From: [Victoria Leung](#)
To: [Docket, Hearing](#)
Subject: [External_Sender] Riverkeeper Comments for Docket ID NRC-2020-0021
Date: Wednesday, March 25, 2020 5:23:29 PM
Attachments: [2020.03.25 Riverkeeper Comments \(Docket ID NRC-2020-0021\) FINAL.pdf](#)

**Re: Riverkeeper, Inc. comments regarding the Proposed License Transfer of
Indian Point Energy Center (Docket Nos. 50-3, 50-247, 50-286, 72-051)**

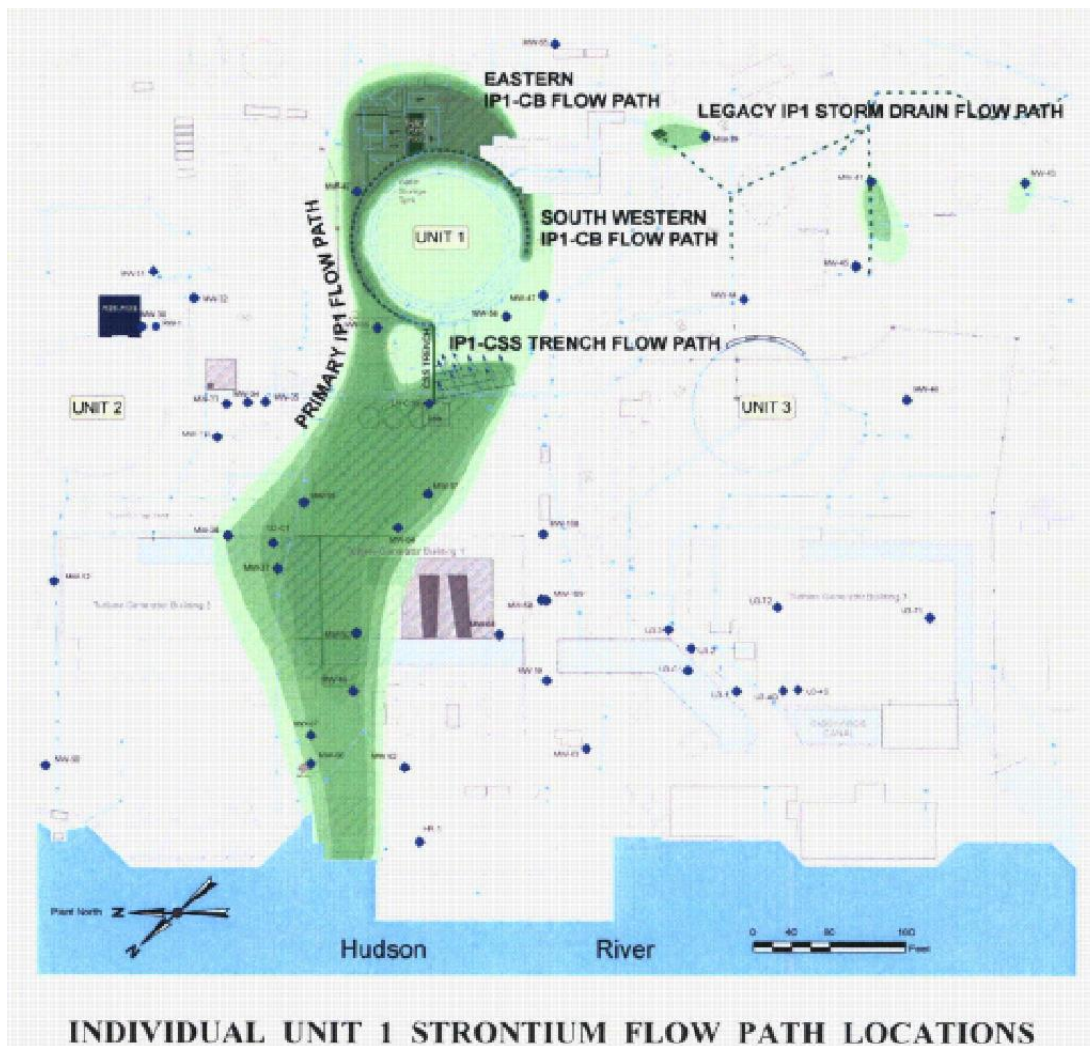
easier access routes. All of these changes could invalidate the assumptions upon which the LTMP rely. The PSDAR assumed that the existing LTMP as-is would continue to function adequately throughout decommissioning without justifying why activities could not undermine its effectiveness.

The monitoring well locations (represented by blue dots in the figure) and the depths of sensors installed in the locations relied on the existing hydrogeological conditions and the assumption of a groundwater recharge rate of 10 inches per year. If decommissioning activities alter the onsite groundwater flow paths or increase the recharge rate, the LTMP may be adversely affected. The report on the hydrogeological evaluation report expressed the limitation of its assessment:

INDIAN POINT 2

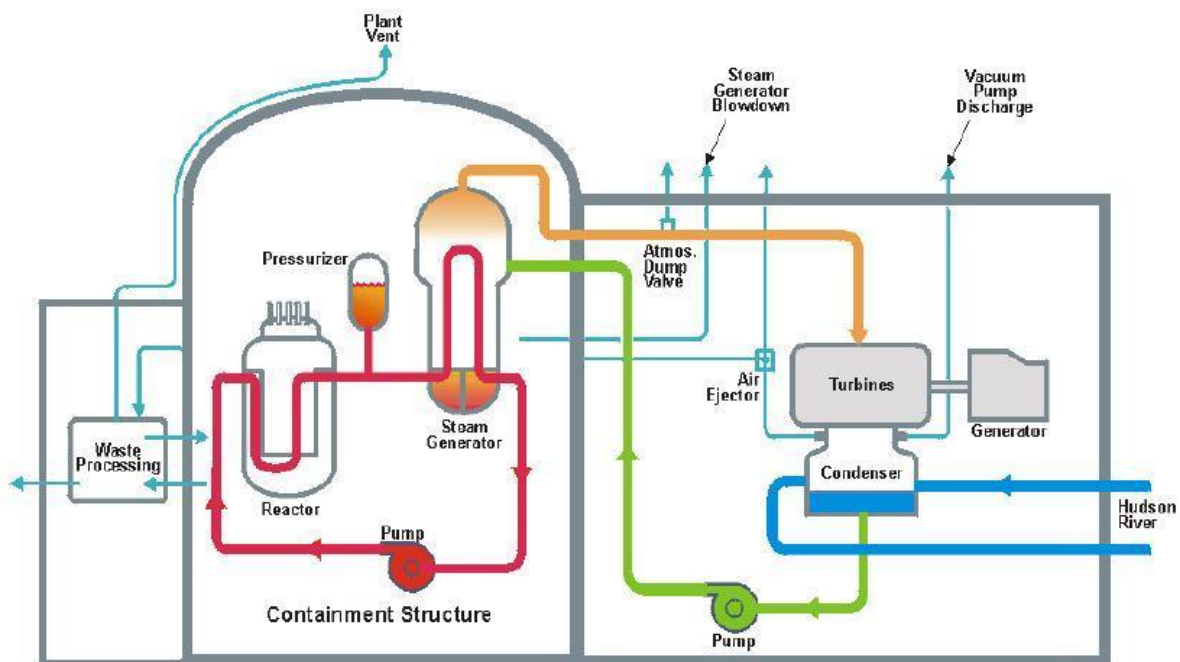
The turbine and condenser to be segmented using “appropriate radiological precautions” are shown on the right side of the Indian Point 2 schematic. The main steam pipes (orange line) carry steam from the steam generators housed within the containment structure to the turbine. The condensate and feedwater pipes (green line) recycle water from the condenser back to the steam generators. Called the secondary loop, these pipes and components are normally “clean” radioactively. But, as the PSDAR stated, the rupture of a tube within a steam generator in February 2000 allowed radioactively contaminated water to leak, flash to steam, and get transported to the turbine and condenser and contaminate them radioactively.

If the tube had not failed, the Unit 2 turbine and condenser would presumably not be contaminated with radiation. Yet, whether the tube leaked or not, the radioactively contaminated water (red line) flowing through the Unit 2 steam generators that day — and literally thousands of days before and after that day in February 2000 — would have subjected those steam generators to radioactive contamination. If one leaking tube on one day compels “appropriate radiological precautions” for the Unit 2 turbine and condenser, it seems grossly inappropriate for the Unit 2 (or Unit 3 for that matter) steam generators to be removed without “appropriate radiological precautions.” Yet the PSDAR was silent on the subject, other than to mention the steam generators would be removed. That description provided the NRC with no useful information to properly develop and apply its oversight efforts.
